Sundry Print Report

Well Name: COTTON DRAW 32
STATE FED COM

Well Number: 3H

Notice of Intent

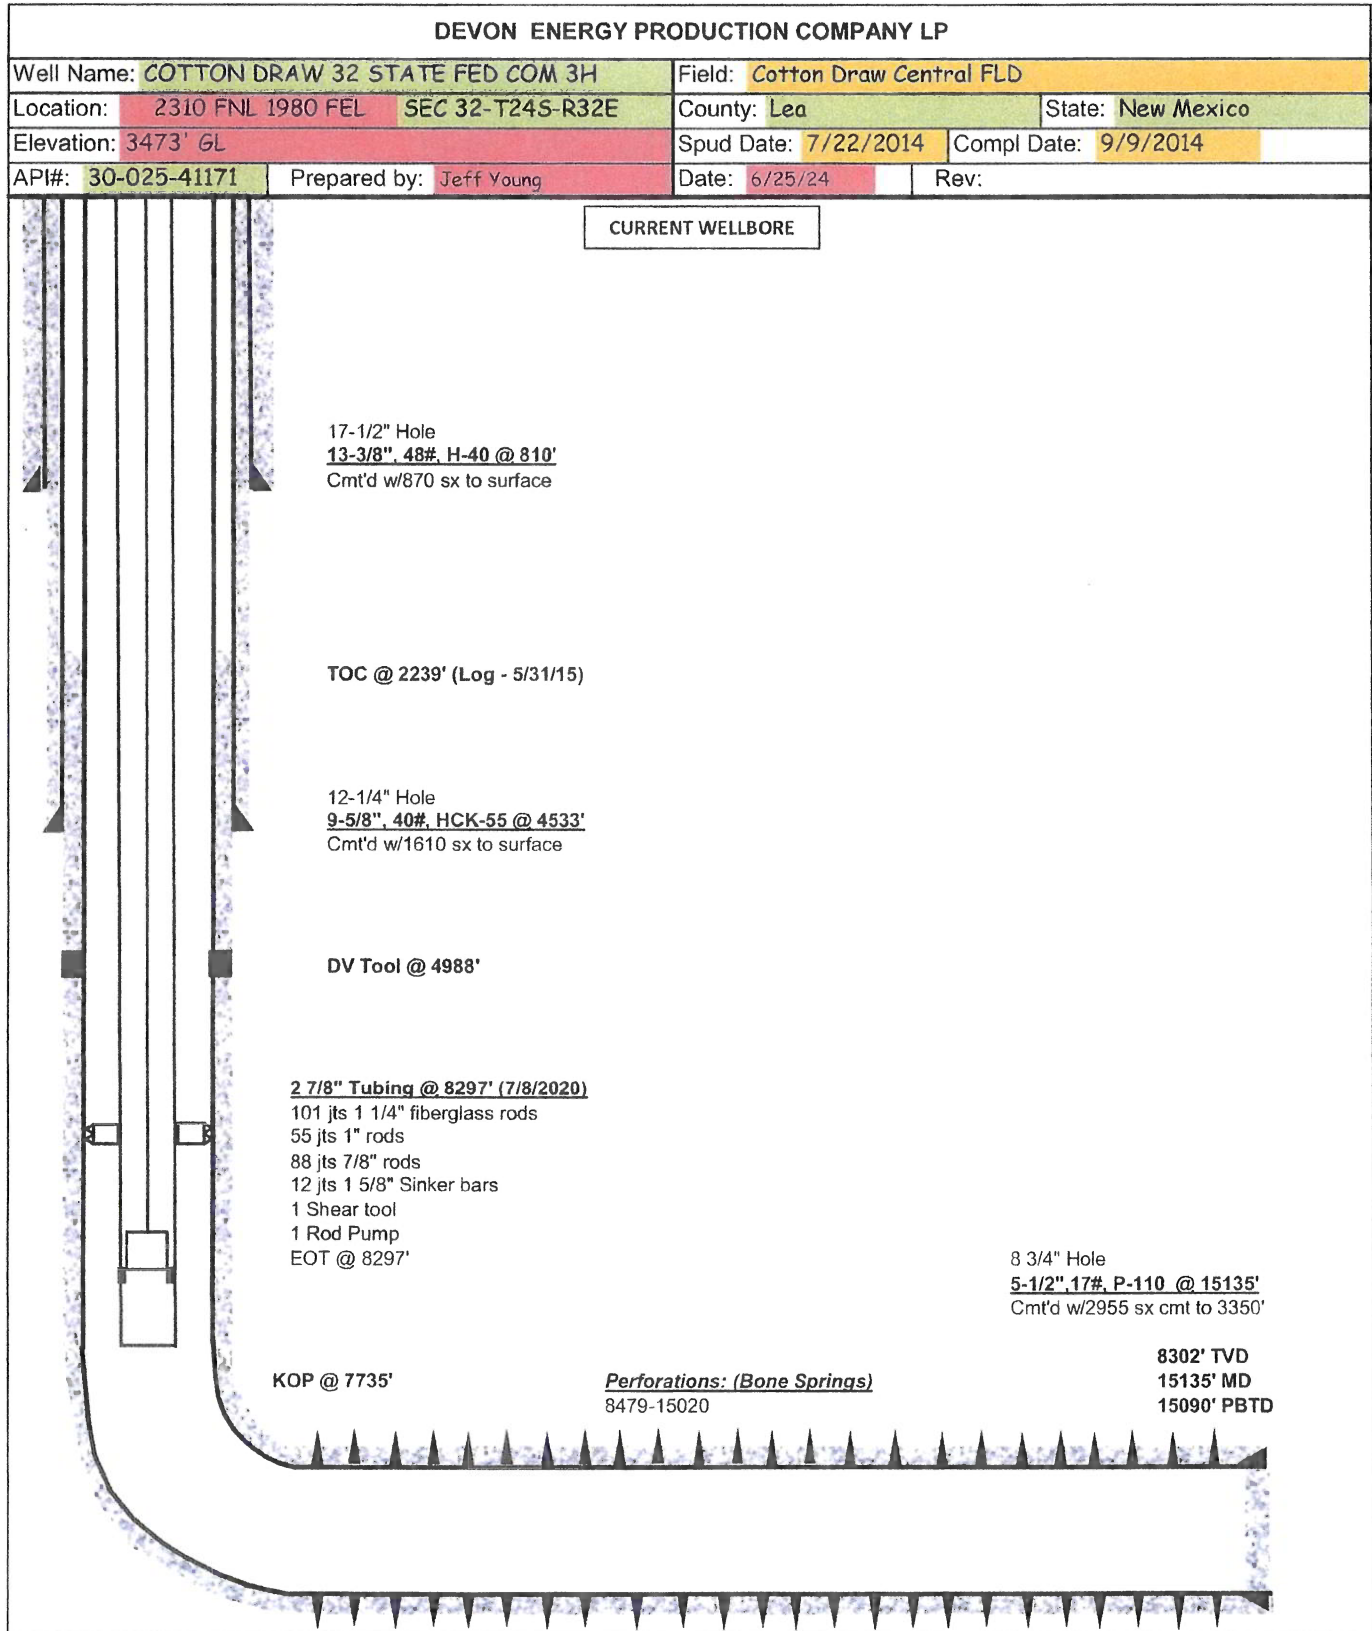
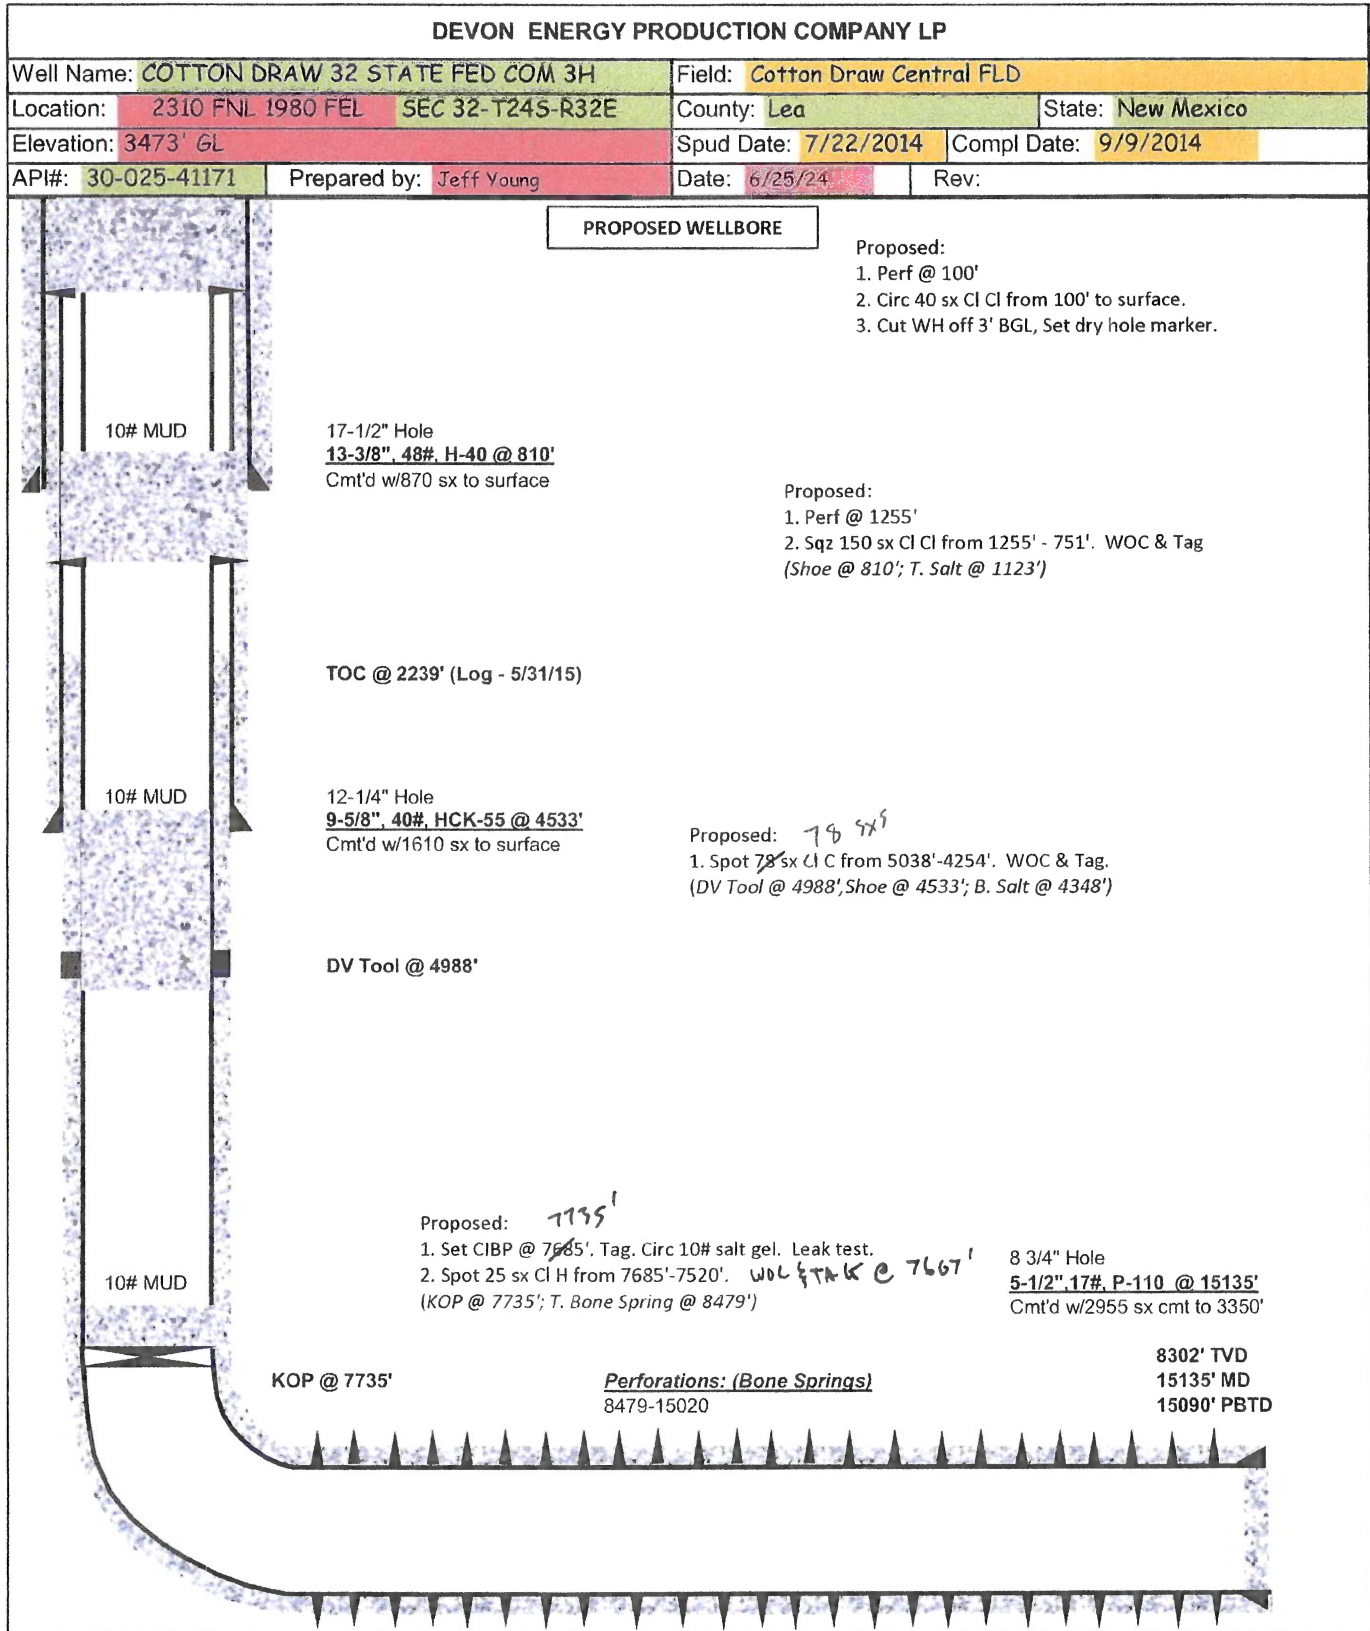
1. MIRU P&A unit. TOOH w/ TBG and Rods from 8297'
2. Set CIBP @ ~~7685'~~ Tag. Circ 10# salt gel. Leak test. **7735'**
3. Spot 25 sx CI H from ~~7685'-7526'~~ (KOP @ 7735'; T. Bone Spring @ 8479') **(7735' to 7601') WOC & TAG**
5. Spot 78 sx CI C from 5038'-4254' (DV Tool @ 4988'; Shoe @ 4533'; B. Salt @ 4348')
8. Perf @ 1255'; Sqz 150 CL C from 1255'-751' WOC & Tag. (Shoe @ 810'; T. Salt @ 1123')
9. Perf @ 100'; Circ 40 sx CI CI from 100' to surface.
10. Cut WH off 3' BGL, Set dry hole marker.

Plug Type	Top	Bottom	Length	Tag	Sacks	Cement Class	Notes
Surface Plug	0.00	100.00	100.00	Tag/Verify	30.00	C	Perf and squeeze from 100' to surface.
13.375 inch- Shoe Plug	751.90	860.00	108.10	Tag/Verify			
Top of Salt @ 1123	1061.77	1173.00	111.23	Tag/Verify	126.00	C	Perf and squeeze from 1173' to 751'. WOC and Tag. (In 42 sxs/Out 84 sxs)
Base of Salt @ 4348	4254.52	4398.00	143.48	Tag/Verify			
9.625 inch- Shoe Plug	4437.67	4583.00	145.33	Tag/Verify			
Delaware @ 4563	4467.37	4613.00	145.63	If solid			
DV tool plug	4888.12	5038.00	149.88	Tag/Verify	78.00	C	Spot cement from 5038' to 4254'. WOC and Tag.
5.5 inch- Shoe Plug	7607.65	7785.00	177.35	Tag/Verify			
CIBP Plug	7700.00	7735.00	35.00	If solid			
Perforations Plug (If No CIBP)	8429.00	15070.00	6641.00	Tag/Verify

Created By	Condition	Condition Date
gcordero	Run CBL from CIBP to Surface.....CBL must be submitted to OCD via OCD Permitting prior to submitting C-103P	8/23/2024
